"Georgian Water and Power"

MARNEULI DIRRECTION PUMPING AREA

ASSESSING HEALTH AND SAFETY CONDITIONS IN FACILITIES AND WORK AREAS AND PLANNING IMPROVEMENT MEASURES

16.09.2025

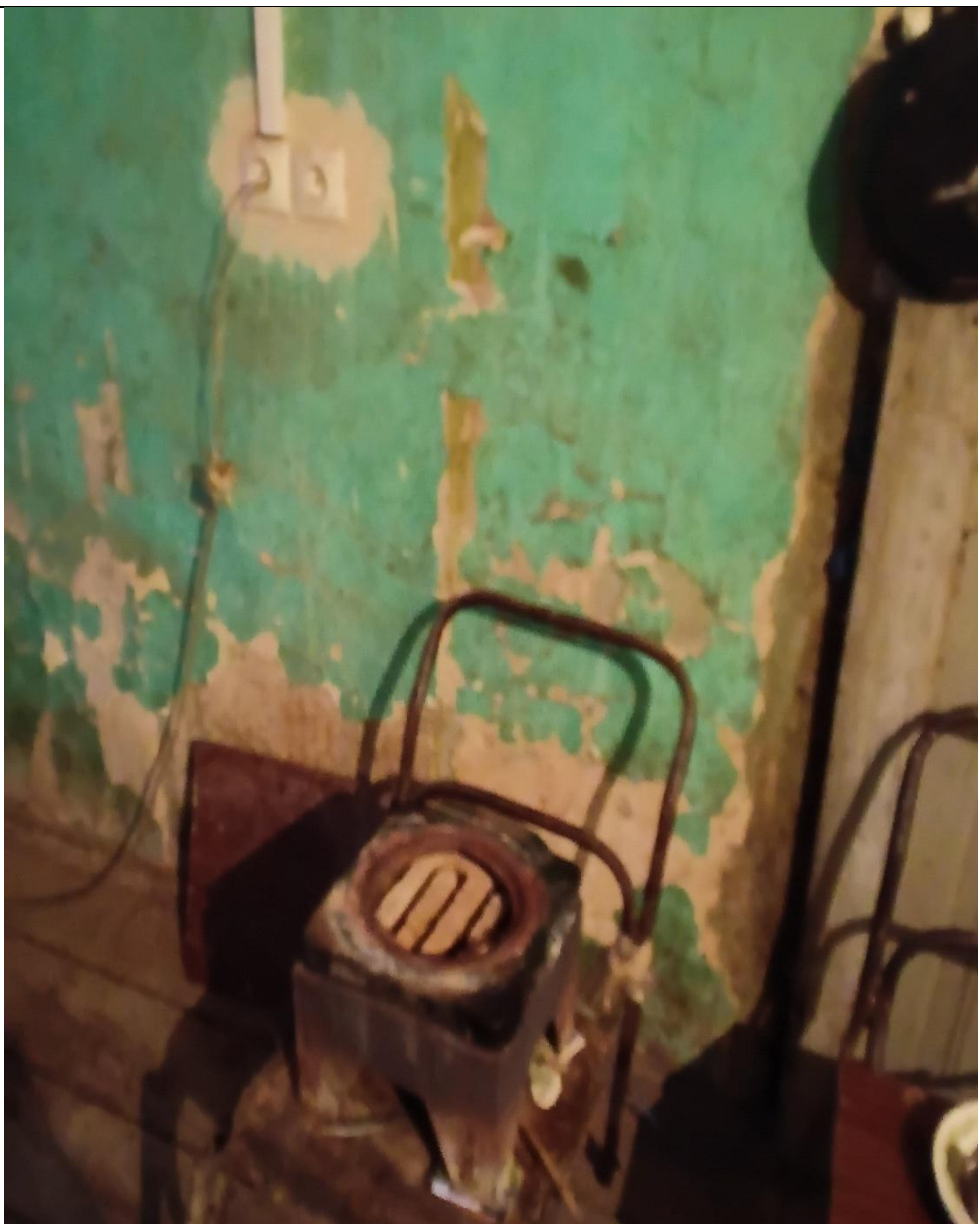
The employee's workspace is inappropriate in terms of ergonomics.

The employee's space should be furnished according to the standard, it needs renovation.
